**PLANNED UNIT DEVELOPMENT,
PLANNING APPROVAL,
ZONING & SUBDIVISION STAFF REPORT****Date: July 9, 2015**

<u>NAME</u>	Historic Restoration Society, Inc.
<u>SUBDIVISION NAME</u>	Lone Oak Subdivision, Lot 1, Resubdivision of Lot 1/Lot 2
<u>LOCATION</u>	901, 903, & 911 Dauphin Street and 2, 6, 10, & 14 South Broad Street (Southwest corner of Dauphin Street and South Broad Street, extending to the North side of Conti Street)
<u>CITY COUNCIL DISTRICT</u>	District 2
<u>PRESENT ZONING</u>	<i>R-3, Multiple- Family Residential District, B-1, Buffer Business District, and B-4, General Business District</i>
<u>PROPOSED ZONING</u>	B-2, Neighborhood Business District and B-4, General Business District
<u>AREA OF PROPERTY</u>	2 lots / 4.5 acres \pm
<u>CONTEMPLATED USE</u>	Subdivision approval to create two legal lots, Planned Unit Development Approval to allow multiple buildings on a single building site and shared access and parking between two building sites, Planning Approval to allow a float barn in a B-4, General Business District, and <i>Rezoning from R-3, Multiple- Family Residential District, B-1, Buffer Business District, and B-4, General Business District, to B-4, General Business Dist

SITE PLAN

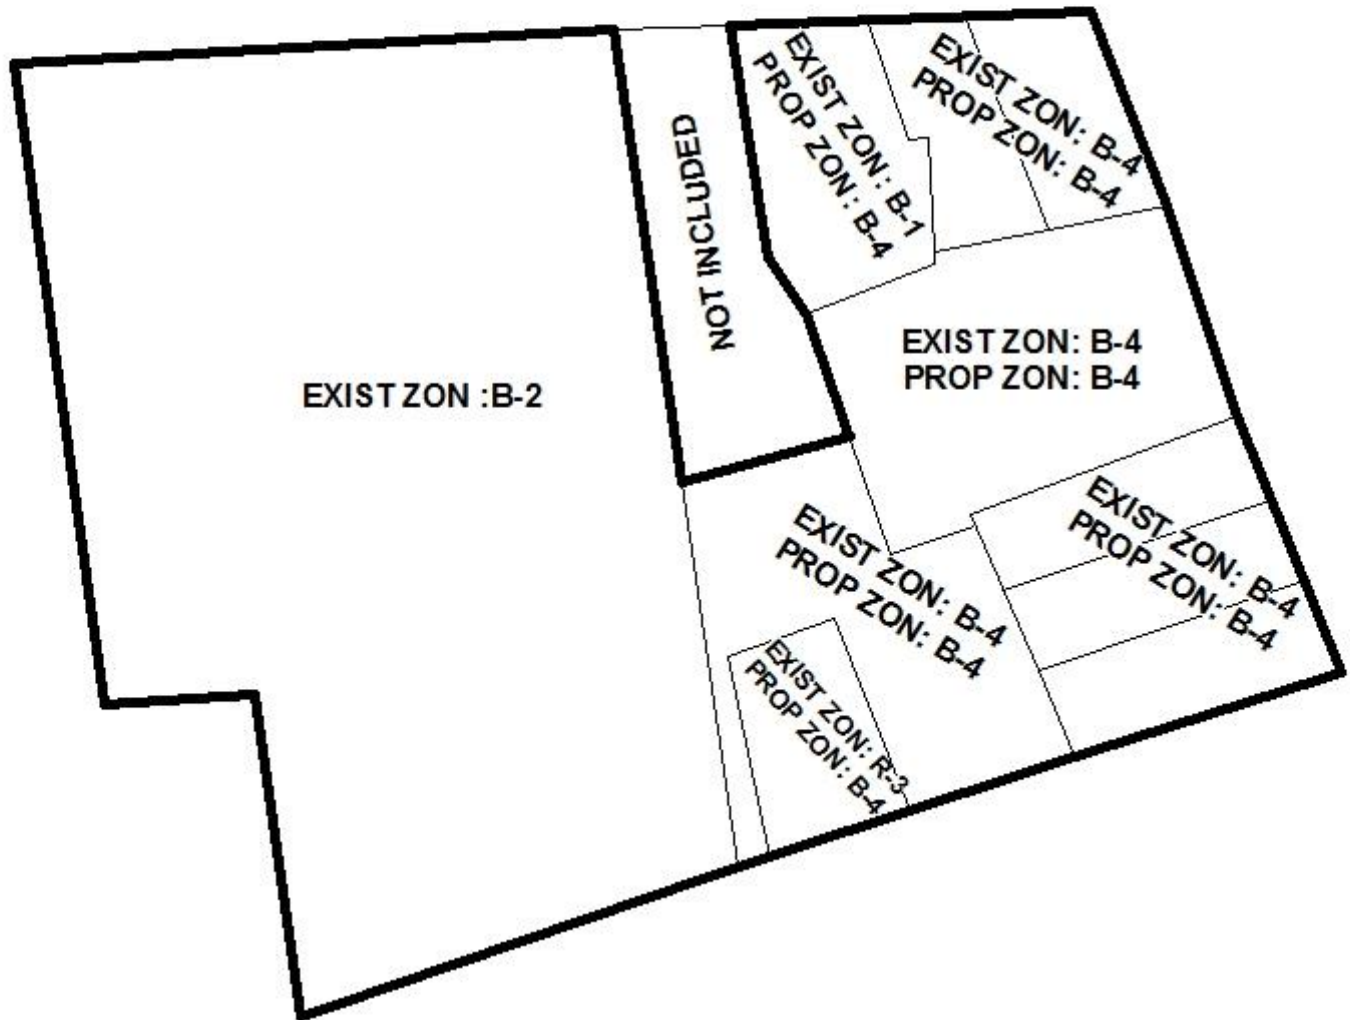
Given the congested nature of the segment of Broad Street between Spring Hill Avenue and Government Street, access management is of concern. Traffic Engineering notes that Broad Street is an ALDOT maintained roadway. Neither the preliminary plat nor the site plan depict all existing curb-cuts along all abutting streets, including the numerous curb-cuts along Broad

Street, and the residential curb-cuts along Conti Street. It is recommended that both the preliminary plat and the site plans be revised to accurately depict all existing curb-cuts and indicate which are proposed to remain and which are proposed to be removed.

The preliminary plat should be revised to provide a corner radius at the Dauphin / Broad Street intersection, and at the Broad / Conti Street intersection.

It should also be noted that the preliminary plat does not clearly delineate which property will be Lot 1 and which will be Lot 2, nor where the boundary line between the two will be situated.

The site plan depicts two float barns, one of which will be 9,000 square feet, and the other 4,800 square feet. These two new buildings would be behind the two existing buildings on Lot 2, which front Dauphin Street and Broad Street. The applicant will use the existing buildings for incidental uses associated with the float barns. While new trees are proposed along Broad Street and Dauphin Street for Lot 2, the interface depicted does not appear to reflect the pedestrian-oriented, architecturally engaging mixed-use spirit of either the Bring Back Broad Street initiative or the New Plan for Mobile.

For Lot 1, other changes include two proposed additions to the existing Orphanage building, including a 390 square foot restroom facility and an unspecified 1125 square foot addition. Two new parking spaces are shown near these additions, however, there does not appear to be any way to reach the parking spaces without driving through designated landscape areas.

That portion of the proposed Lot 1 that will be located behind the residential structures fronting Conti Street, and that portion of Lot 2 that will surround the proposed float barns are shown as being surfaced in “crushed concrete.” Such a surface is not allowed for parking or maneuvering, thus either a surfacing variance will be required, or all areas that will be used for parking or maneuvering must be paved in concrete, asphalt or alternative approved surface as defined by the Zoning Ordinance.

Finally, if the overall PUD will be enclosed with fencing or similar, such should be noted on the site plan.

Staff has concerns regarding the tree and landscape aspects of the plan. The site plan shows three existing live oaks at the Conti/Broad Street intersection as being on private property when it actually appears that the trees are between the sidewalk and the curb, within the public right-of-way on Conti Street. Also, given the existing number of live oak trees on or adjacent to the property, the proposed tree planting depicted on the site plan may result in an overplanting and overcrowding situation, as most of the proposed over story trees will have to be live oak trees due to overhead power lines. Staff suggests that the Planning Commission allow the applicant to coordinate tree plantings with staff, with the understanding that some tree banking may be required.

The site plan depicts a 6-foot high wooden privacy fence where the site abuts R-1 property on the Western side of the site. This fence should be provided prior to use of the site.

The applicant has explained the request for crushed concrete surfacing in the float parking and maneuvering area, and crushed rock in the service yard area. A paved apron should be provided at any curb-cut entering into the alternate surfacing area if required by Engineering and Traffic Engineering, to be coordinated with Engineering and Traffic Engineering. Additionally, the crushed rock and crushed concrete areas should have barriers such as bumper stops to prevent vehicles from encroaching into landscape areas or into the adjacent right-of-way. Bumper stops should also be required for those paved parking spaces abutting landscape areas or near property lines.

The revised plan shows that numerous existing curb-cuts will be removed on proposed Lot 2, leaving two curb-cuts onto Dauphin Street, one onto Broad Street, and one onto Conti Street. A right-in only curb-cut for Lot 2 on Dauphin Street will be gated, and the curb-cut on Conti Street will also be gated: the gates are proposed to be setback between 20 to 30 feet from the respective rights-of-way. The six-foot high ornamental fence depicted around most of the outside perimeter of Lot 2 appears to break at the proposed curb-cut onto Broad Street, thus it appears that this access point will not be gated. There is nothing on the plan to indicate that the two access points for Lot 1 will have any gates, however, the ornamental fence will be placed along Lot 1's frontage along Dauphin Street, stopping before the curb-cut.

- 1) *Curb-cuts limited to the revised site plan, with all unused curb-cuts to be removed prior to a certificate of occupancy for the proposed float barns;*
- 2) *Revision of the site plan to depict any paved curb-cut aprons leading to the crushed rock or concrete surfaces, to be coordinated with Engineering and Traffic Engineering if such aprons are required;*
- 3) *Revision of the site plan to show the three existing live oak trees on Conti Street at Broad Street as being within the public right-of-way, between the sidewalk and the curb, rather than on Lot 2;*
- 4) *Coordination with Planning staff regarding the location and spacing of proposed trees on the site, with the understanding that tree banking may be required;*

- 5) Provision of a six-foot high wooden privacy fence along the Western boundary of the property where it abuts R-1 properties prior to the use of the site;

- 6) Revision of the site plan to show bumper stops for paved parking areas abutting property lines or landscape areas;
- 7) Revision of the site plan to show bumper stops or similar barriers around the crushed rock and crushed concrete areas to prevent vehicles from encroaching into landscape areas or across property lines;
